TECHNICAL REPORT
STRUCTURAL STRESSES INDUCED BY
DIFFERENTIAL SETTLEMENT OF THE
DIESEL GENERATOR BUILDING

CONSUMERS POWER COMPANY
MIDLAND PLANT UNITS 1 AND 2

ENCLOSURE 2

FIGURE 1

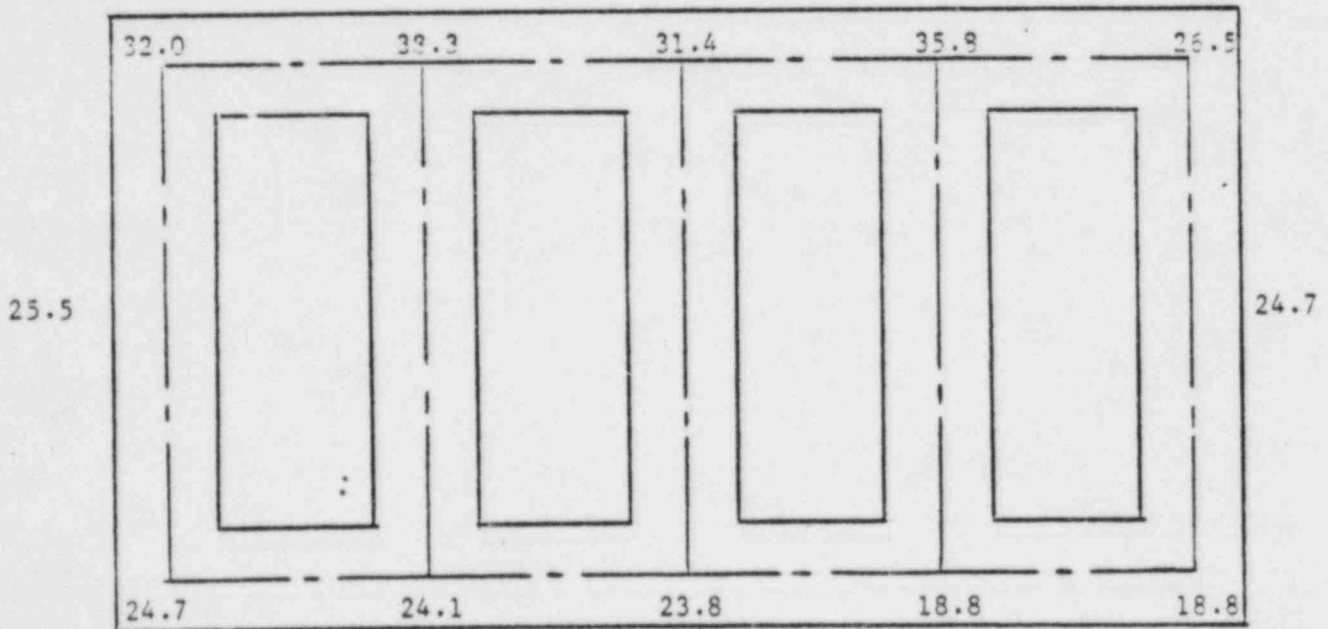
The subgrade moduli for the long-term settlement condition of the diesel generator building were developed from the settlement of the structure after the surcharge was removed neglecting the immediate heave which occurred following load removal, September 14, 1979, to December 31, 2025. Figure 2 contains the contact pressures used to determine these subgrade moduli.

1. Vertical subgrade modulus - The subgrade moduli of the selected points along the exterior wall footings are shown in Figure 1.
2. Horizontal spring constants - The horizontal spring constants given previously for the short-term static or dynamic case can also be used for the long-term static case. This is because horizontal displacements are small and in the elastic range.

FIGURE 1
BORING LOCATION PLAN IN AREA OF
DIESEL GENERATOR BUILDING

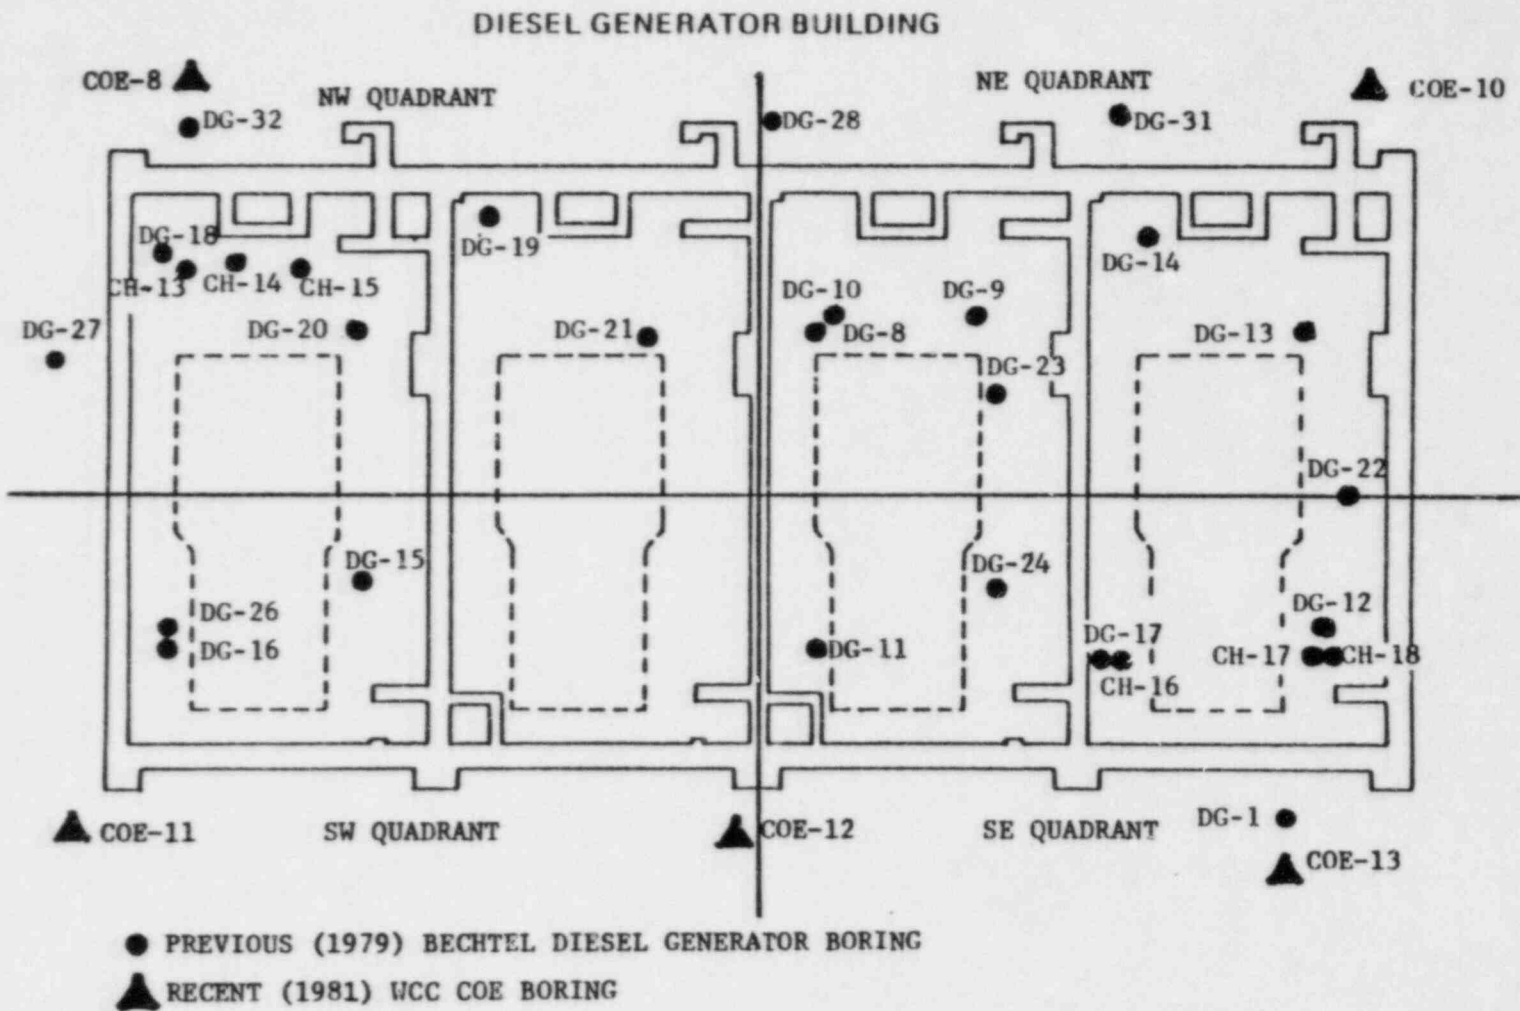
For the purpose of presentation of relative density data the building was divided into four quadrants as shown in Figure 1. The same Figure 1 also shows the location of DG series borings and COE series borings. The relative densities are compared below.

It can be seen from the above comparison that the maximum settlement calculated based on the COE series borings (after surcharge) are lower than that calculated based on the DG series borings (before surcharge). Therefore, the design values of settlement and differential settlement of 1/2 inch provided in the response to 10CFR50.54(f) Question 27 are conservative.
